MEMORANDUM

SUBJECT: Summary of the public process and comments received on the proposal for bicycle lanes on Prosperity Avenue, Hazelwood Street, and Prosperity Road.

PROSPERITY AVENUE & HAZELWOOD STREET (MARYLAND TO IDAHO)

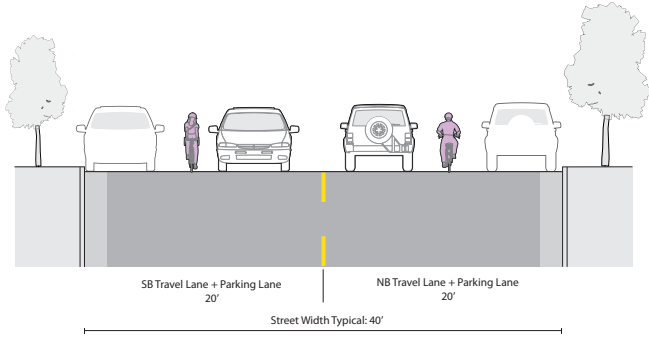
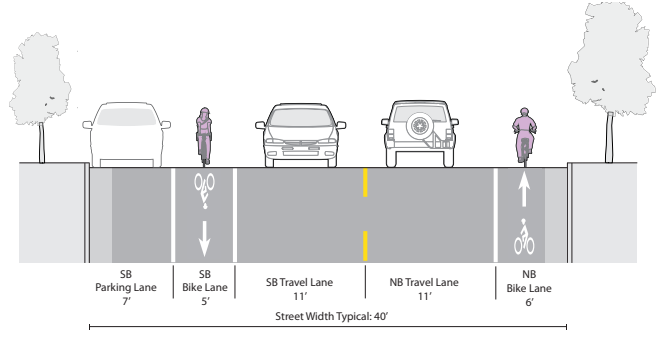
The map you enclosed (I had to take out a magnifying glass to read the dimensions) shows there will be 7' for the car/trucks to park. And each bike lane is allowed 5' and 6'. I am not sure why a bike needs this amount of room. Also the map shows, NB and SB for bike lanes. I assume the SB would be on the west side of the street (even) and the NB is the east side of the street (odd).

MY ONLY SUGGESTION FOR YOUR CONSIDERATION IS ~~TO~~ (ON THE 40-FOOT WIDTH SECTIONS) MAKE THE BIKE LANE ON THE NON-PARKING SIDE ~~5~~ FIVE FEET, AND THE ~~6~~ BIKE LANE ON THE PARKING SIDE SIX FEET. THIS IS BECAUSE IT'S NICE TO HAVE THE EXTRA FOOT OF WIDTH WHERE YOU HAVE A DOOR-ZONE, WHEREAS ON THE CURB-NON-PARKING SIDE, YOU CAN RIDE NEAR THE CURB, FARTHER AWAY FROM CAR TRAFFIC. THE DECISION TO DO THIS MIGHT BE INFLUENCED BY GUTTER-PAN WIDTH ... BUT THE COUNTY HAS DONE OTHER STREET REPAVINGS WHERE THEY'VE COVERED GUTTER PANS WITH ASPHALT OR USED SHORTER PANS (WITH STREET REBUILDS).

PROSPERITY ROAD

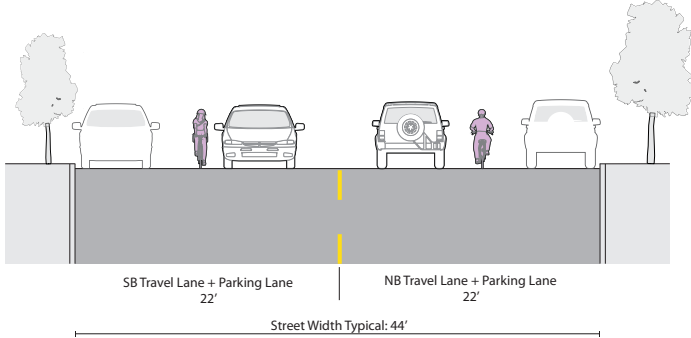
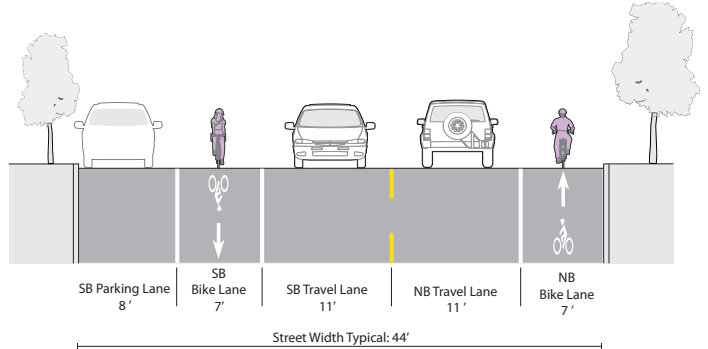
This is in regards to the proposal to install bike lanes on Prosperity Road. I live at 1665 Prosperity Road, in the block between Idaho and Larpenteur. I have lived here 25 years. I strenuously object to the installation of the proposed bike lanes on this block. First, parking is already a problem on this block. I am attaching 2 photos I took last Sunday which depict the east side of the road on that block. There are no alleys behind the houses on either side of Prosperity Road, so all parking is either driveway or street. Second, the lanes would create a serious safety issue. There is a sidewalk on both sides available for bikes. The proposed bike lanes would force riders to be next to busy traffic lanes, with cars entering the road from driveways and street parking. Prosperity Road is already too busy as the preferred alternative to White Bear Avenue, and the speed limit is largely ignored here. Finally, I have not noticed a great deal of bike traffic on this street. The state trail is only a couple of blocks north, and it is much safer for cyclists. Resurface the road, but leave the traffic and parking lanes as they are now. Gary Davis
